FINAL ENVIRONMENTAL IMPACT REPORT

491 Bayshore Boulevard, Home Depot

2001.0062E

**FINAL
ENVIRONMENTAL IMPACT REPORT**

SITE PLAN FIGURE C&R 6
(Revised EIR Figure 2)

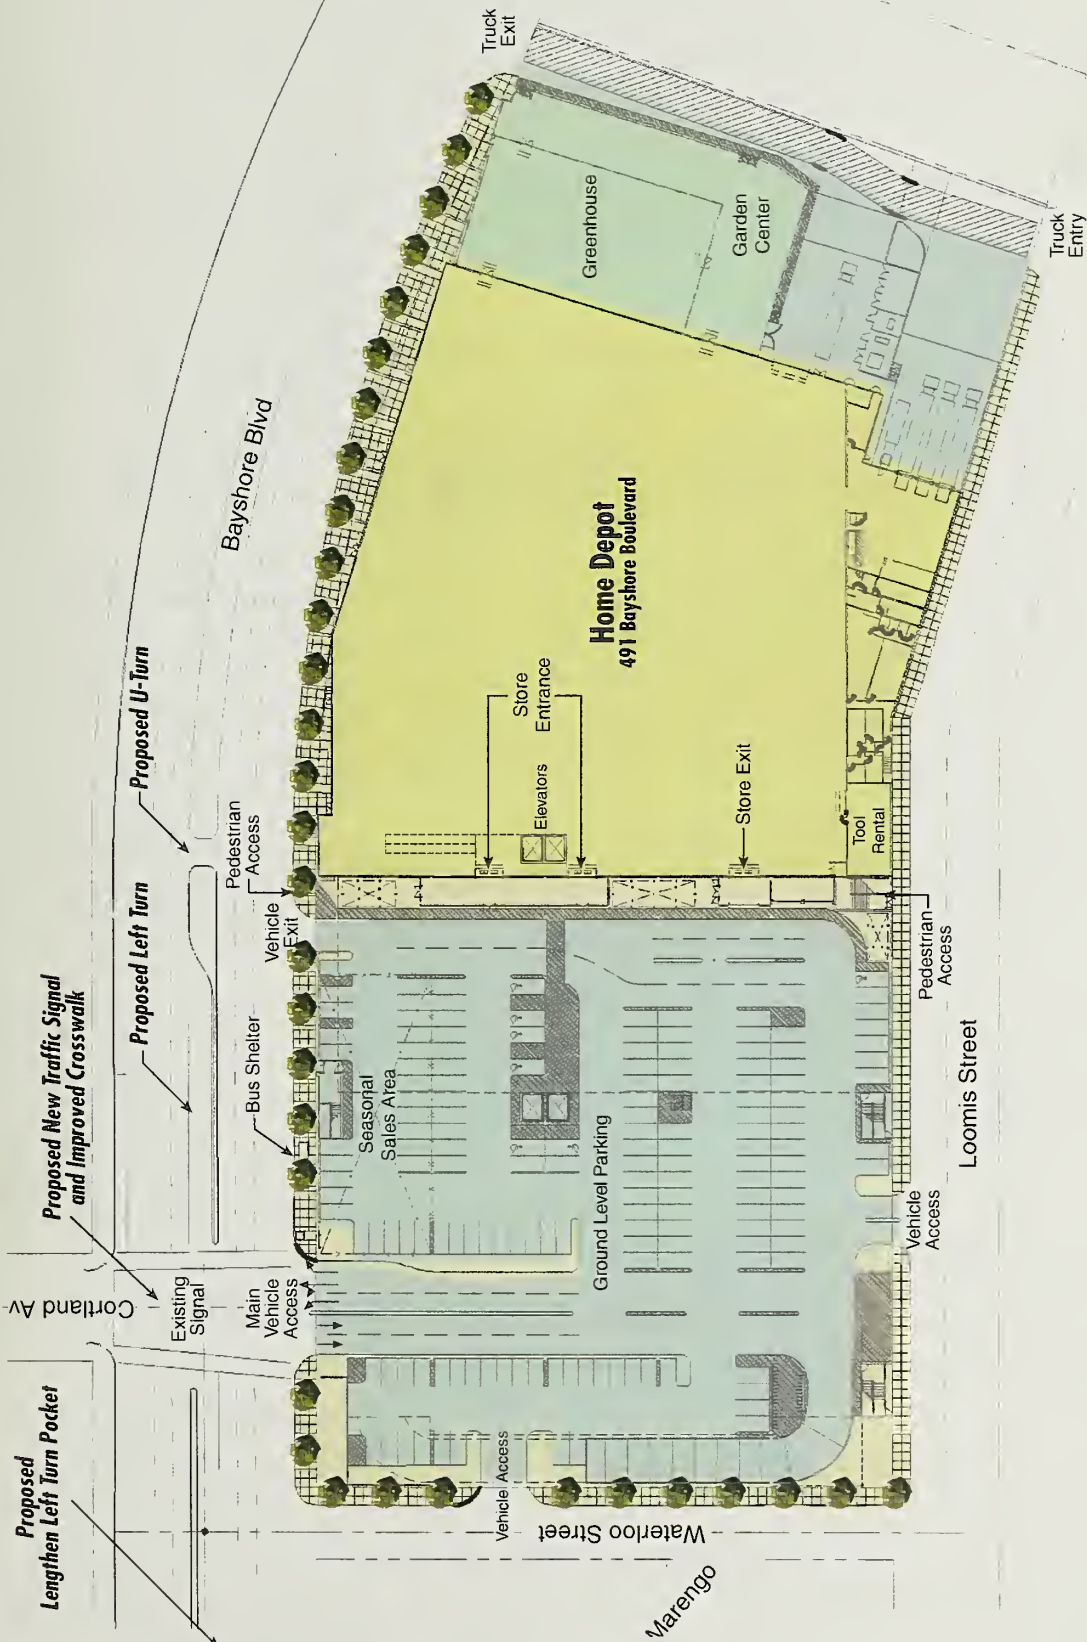
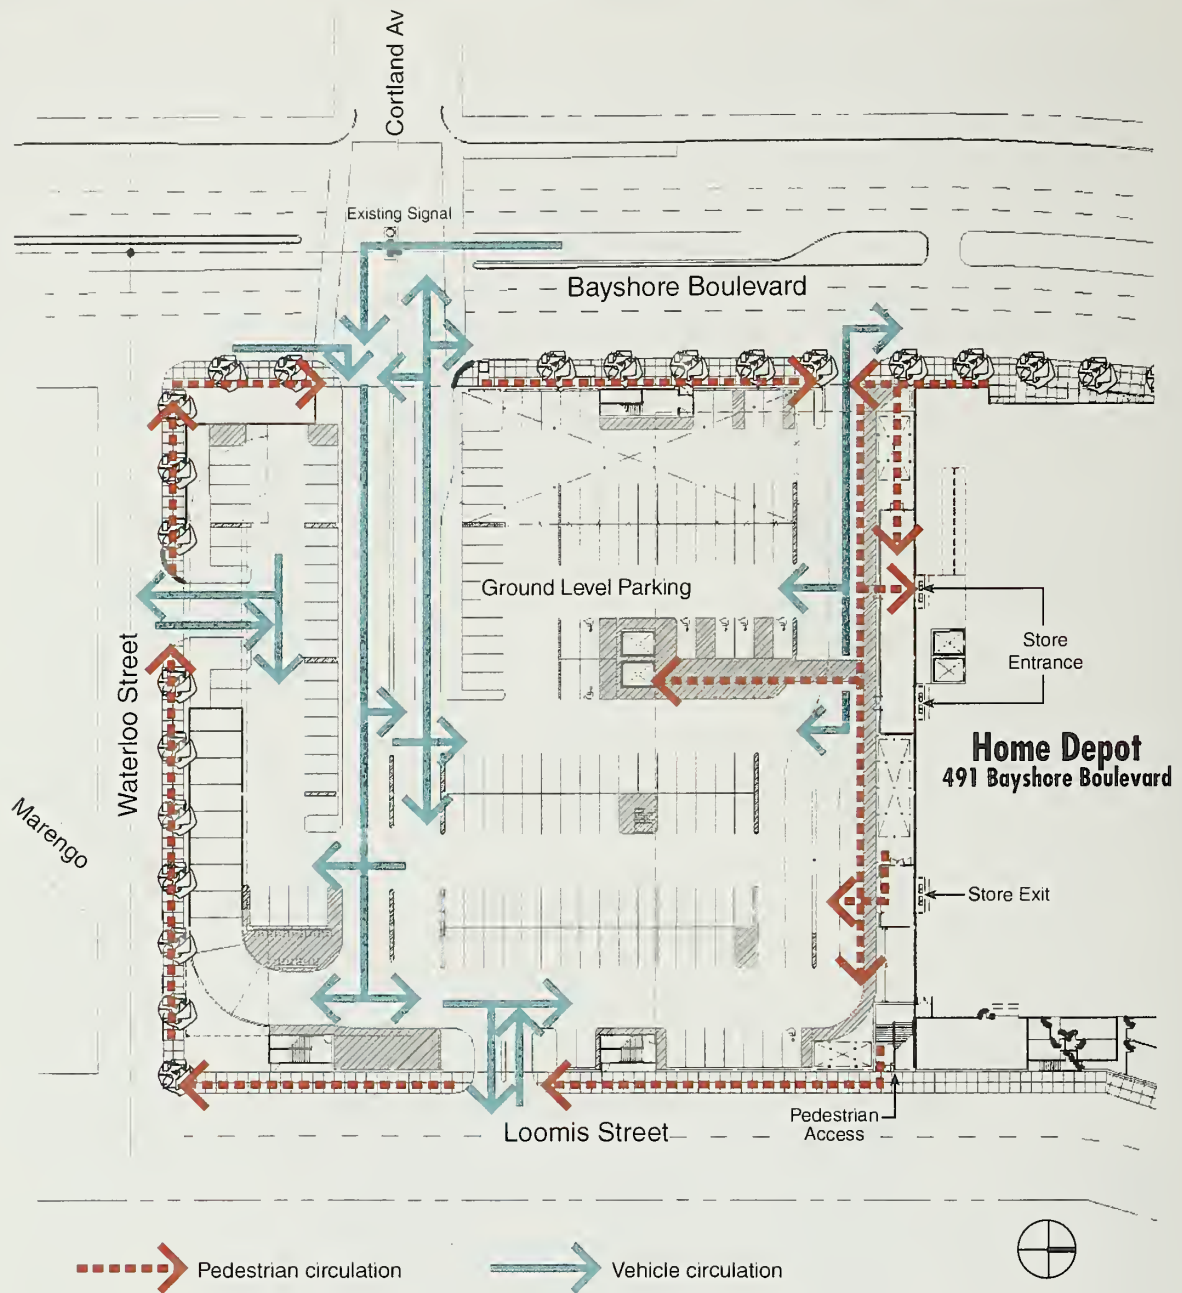
"I live right near the corner of Nevada and Cortland. I'm not affiliated with any group here tonight. I would like to address a couple of things with the EIR. I heard some talk tonight that Home Depot has made a change of their entrance to Loomis Street. Now I would submit to you if they have materially changed their proposal, and that is a material change, that you then have to go back and re-look at your figures here." (*Chris Witteman, Resident, oral testimony*)

"No consideration of access to parking from Loomis Street. Home Depot should not be allowed to change project at last minute without study." (*Chris Witteman, Resident, written comments*)

The main vehicular entrance to the project was always planned to be opposite the Cortland/Bayshore intersection to allow for traffic light control in and out of the project on Bayshore (as shown in Figures C&R.6 and C&R.7, pages C&R.27 and C&R.28. Figure

C&R.6 replaces Figure 2 of the DEIR). As originally proposed, the plans had no ingress or egress on Loomis Street. The addition of the Loomis Street driveway was proposed by Home Depot as a result of discussions with Planning Department staff in order to alleviate some of the traffic at the proposed project's Bayshore entrance. Home Depot has proposed using Bayshore Boulevard for its primary driveways because it is a major arterial and fronts the proposed Home Depot. However, in response to comments submitted on the DEIR, an option using Loomis Street as the main project driveway has been analyzed for consideration by the Planning Commission. Please see Response to Comment #74.
